32 GOLF AVENUE, MONA VALE

ISSUE FOR DEVELOPMENT APPLICATION

REV NO.	DESCRIPTION	REV DATE
A	ISSUE FOR DA APPROVAL	19.01.24
B	UPDATED FOR DA APPROVAL	22.06.24

3 LANDSCAPE AREA - C1.1 OBJECTIVES
DA400 1: 200 @ A1

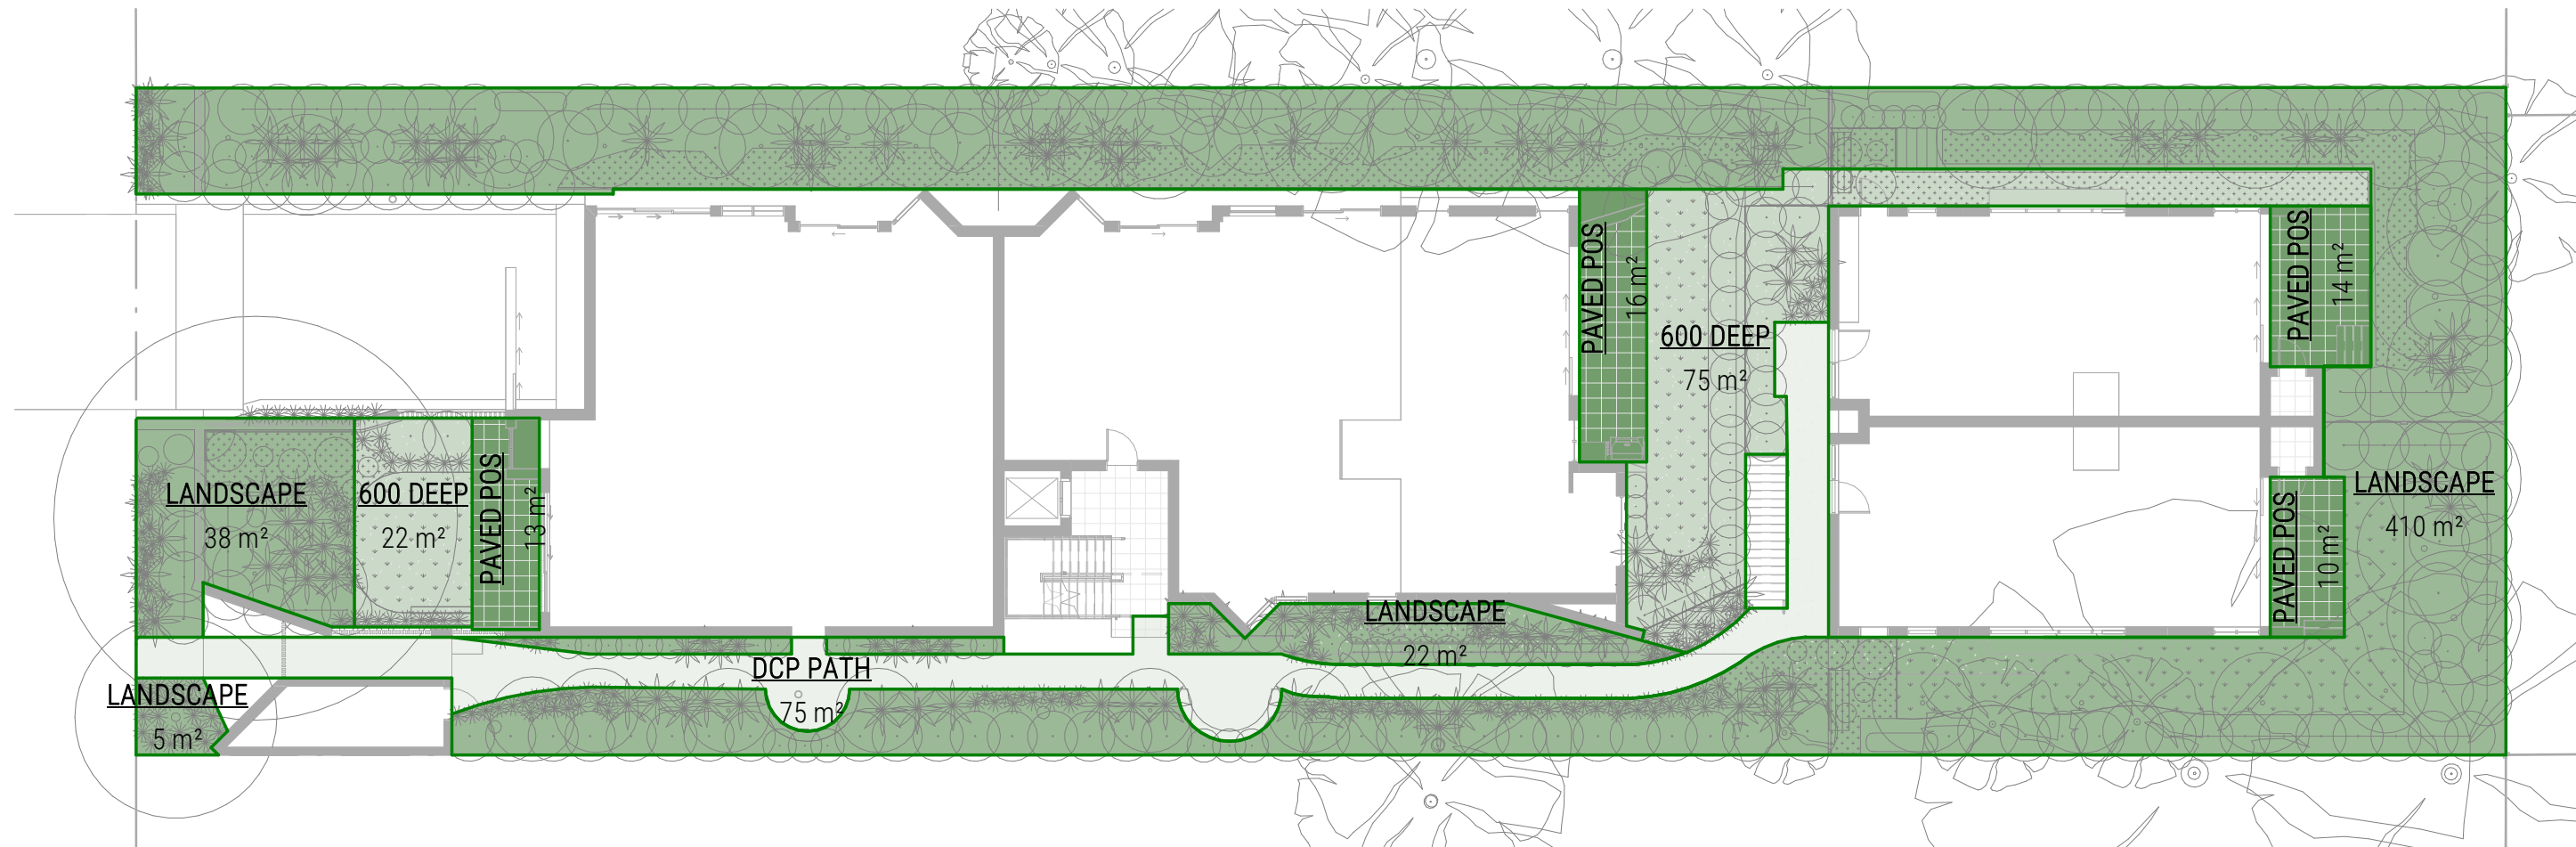
NOTE: THE LANDSCAPE AREAS IN THE MIDDLE, SIDES ARE NOW ALL 600MM INSTEAD OF 800MM AS COUNCIL ASKED TO LOWER THE HEIGHT OF THE TWO REAR UNITS. THIS HAS LOWERED THE PERCENTAGE CALCULATION BUT WE STILL KEPT 600MM AS PER C1.1 OBJECTIVES FOR SHRUBS
